S-3805 HADLEY MOORS SUBDIVISION, PART 7 Major-Preliminary Plat

STAFF REPORT March 9, 2006

PRELIMINARY PLAT HADLEY MOORS SUBDIVISION, PART 7

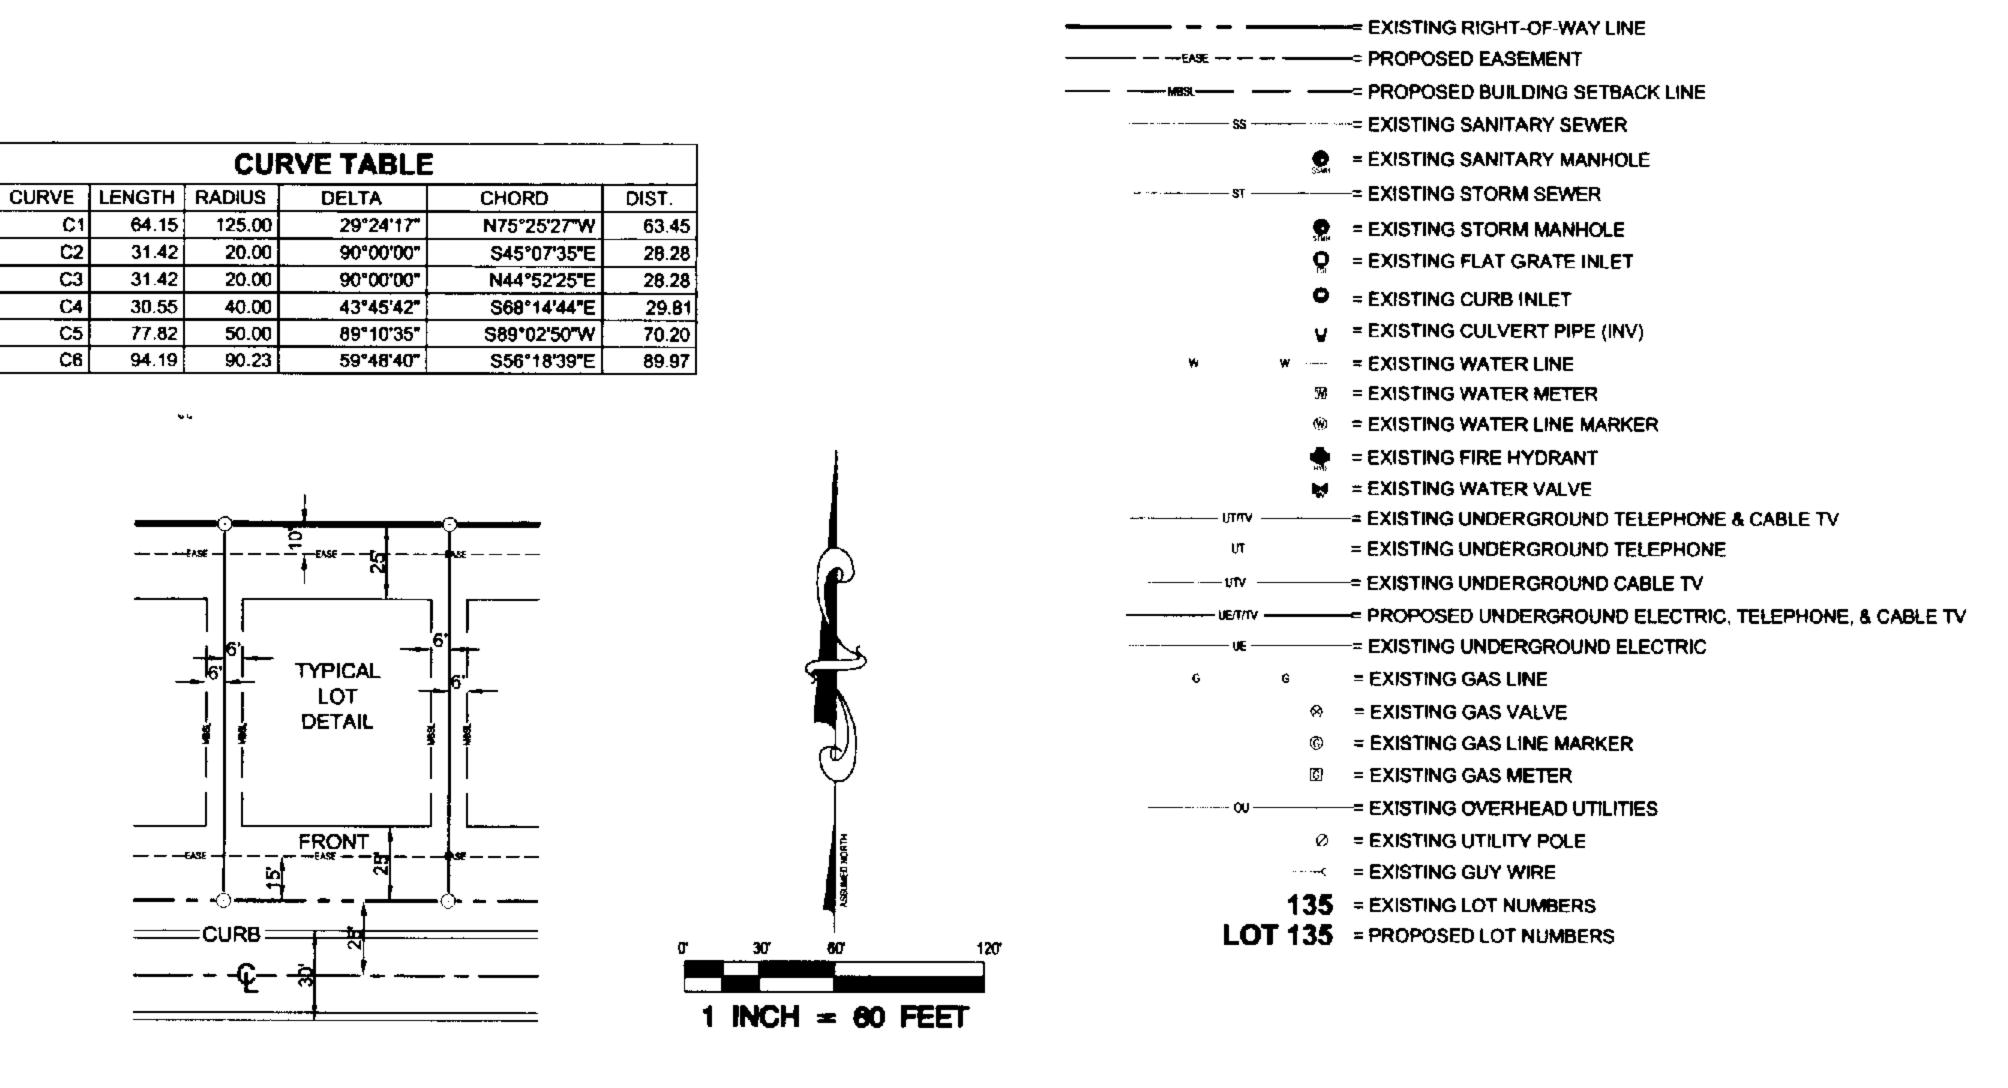
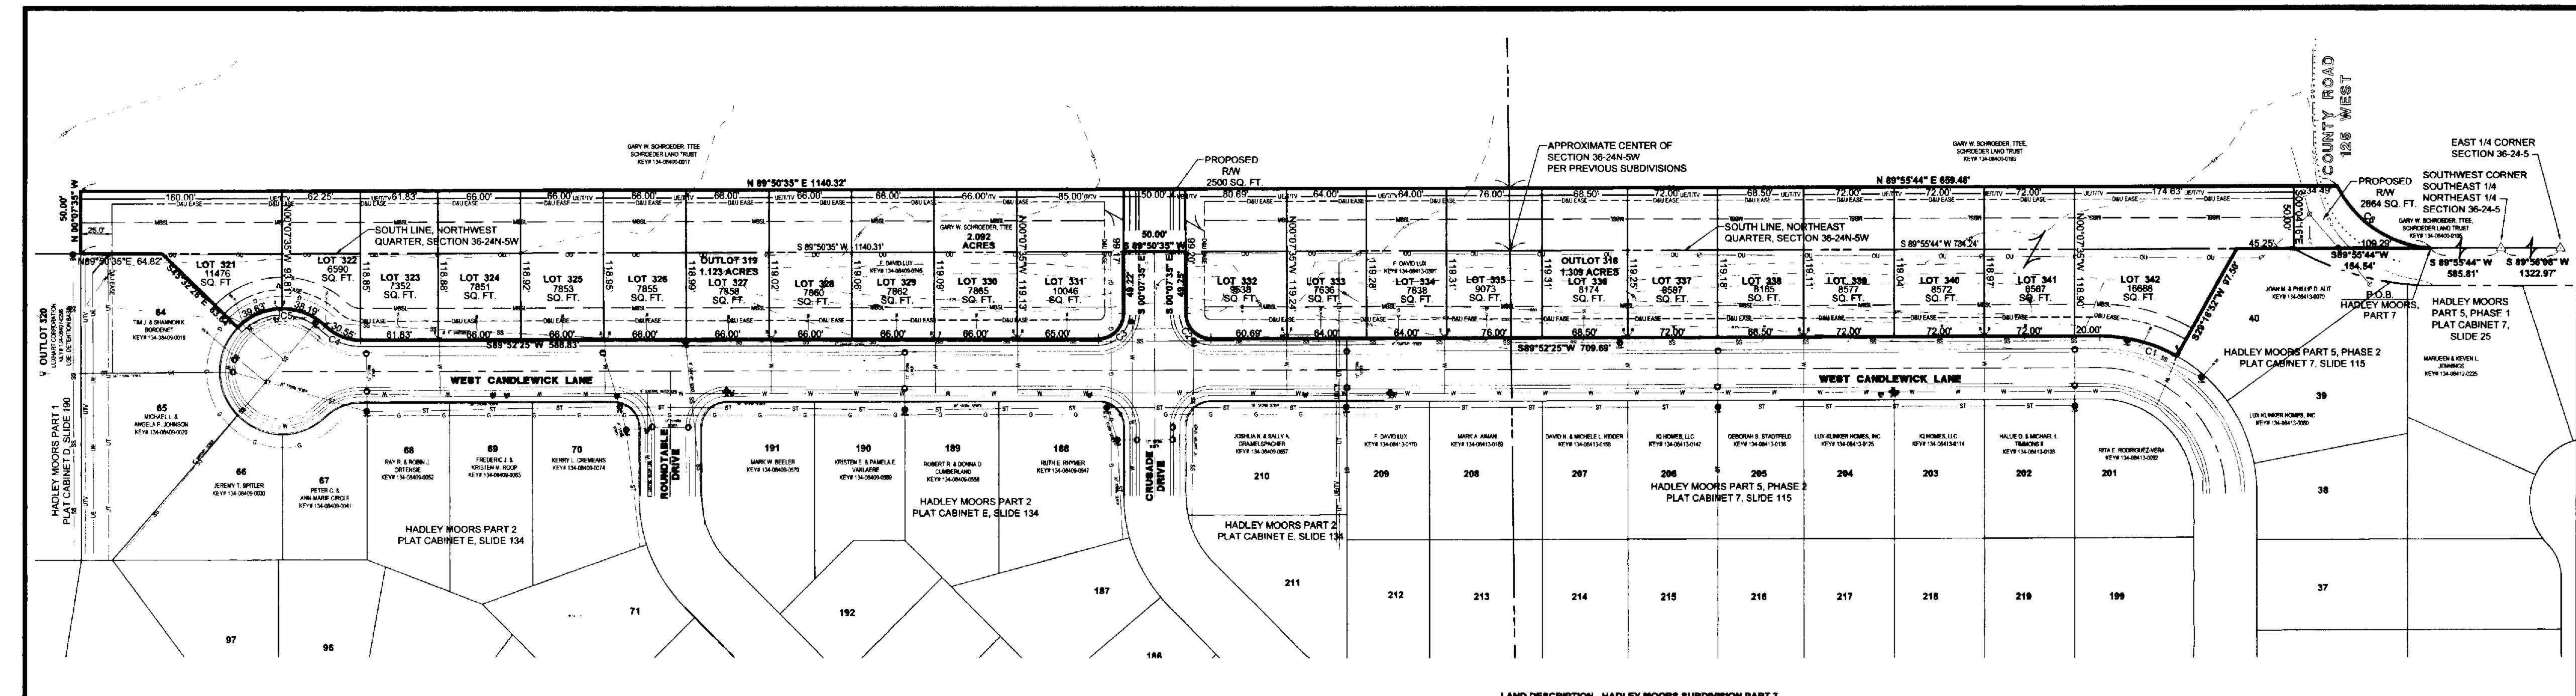
Existing West Candlestick Lane will provide access to all new homes. Located in the middle of this row of lots is a stub street (Crusade Drive) that will be extended 50-ft. to the new subdivision boundary. Lot 342, at the east end of the plat, borders CR 140 W. This frontage will need to be restricted with a "No Vehicular Access" statement on the final plat.

At the rezone hearing this past January, an owner in Hadley Moors, Part 2 (Tim Bordenet) voiced his concern that the new lot abutting his property on the north and east would be an

irregular shaped lot and would adversely affect his property value. His lot (Lot 64) is located at the west end of West Candlestick Lane and adjoins proposed Lot 321. He expressed interest in purchasing a portion of Lot 321 to make both lots more regularly shaped with a shared "radial" side lot line. The rezone petitioner/subdivider (F. David Lux) agreed at the hearing that this could be worked out. At the sketch plan review meeting, staff reviewed this proposal with the subdivider. The solution will be to follow through with the platting as shown on preliminary plat, and then transfer the adjoining portion of Lot 321 to Lot 64 by exemption "e", completing the proposed purchase.

- 7. A "No Vehicular Access" statement shall be platted along the CR 140 W right-of-way line.
- 8. If there is a mortgage on this property, a recorded partial release or written acknowledgment from the mortgage company must be obtained in order to dedicate the necessary right-of-way.

Conditional primary approval, contingent on the following:
